HISTORIC LANDMARK COMMISSION
PERMITS IN NATIONAL REGISTER HISTORIC DISTRICTS
FEBRUARY 22, 2015
NRD-2016-0009
716 Patterson Avenue
West Line

Construct a second story addition to the rear of the house.

716 Patterson Avenue

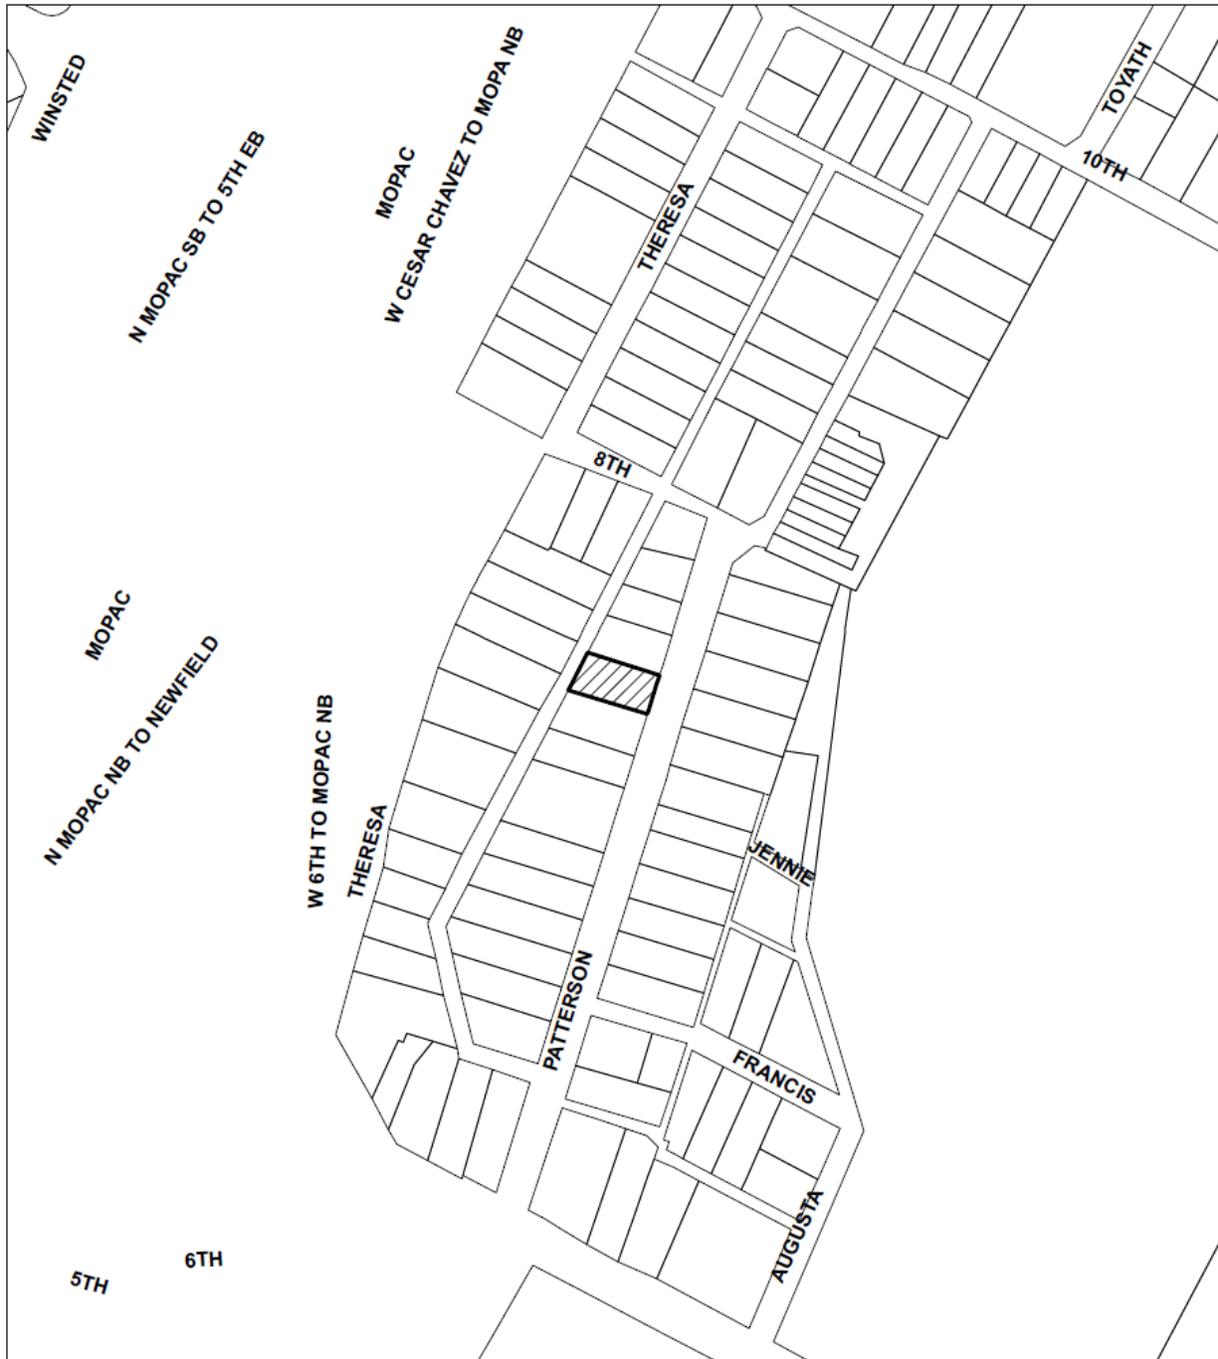
The house is set into the slope of a hill and is located up from the street; the proposed addition will have minimal visibility from the street. Staff recommends consideration of front-facing windows in the addition that are more in scale with the existing windows on the house to the greatest extent possible, but to otherwise release the permit as proposed.
